From: [Planning](#)
To: [Plan Commission Comments](#)
Subject: FW: Oppose: Legistar 86523 (3915 Lien Road (District 3): Consideration of a conditional use)
Date: Monday, March 3, 2025 7:22:52 AM
Attachments: [image.png](#)

From: [Nicholas Davies](#)
To: [Plan Commission Comments](#)
Cc: moliveira@plazastreetpartners.com
Subject: 86523 - textual violations of TOD ordinance
Date: Sunday, March 2, 2025 2:16:04 PM

Regarding item 86523 (3915 Lien Rd), I see several related issues in the current plans:

5 BIKE RACK DETAIL-WAVE TYPE

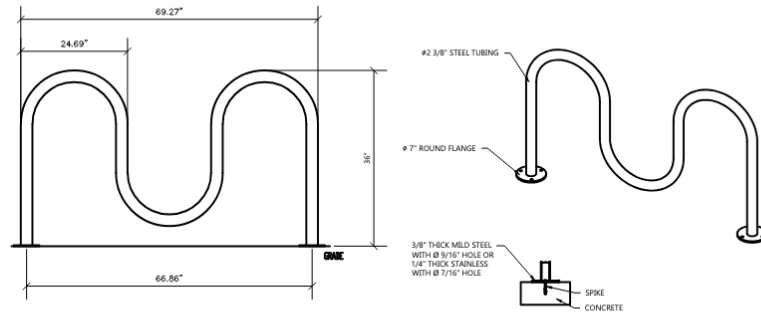
PS Minor detail: I also see a wave-style bike rack in the project plans. I don't think those are compatible with our code for bike parking.
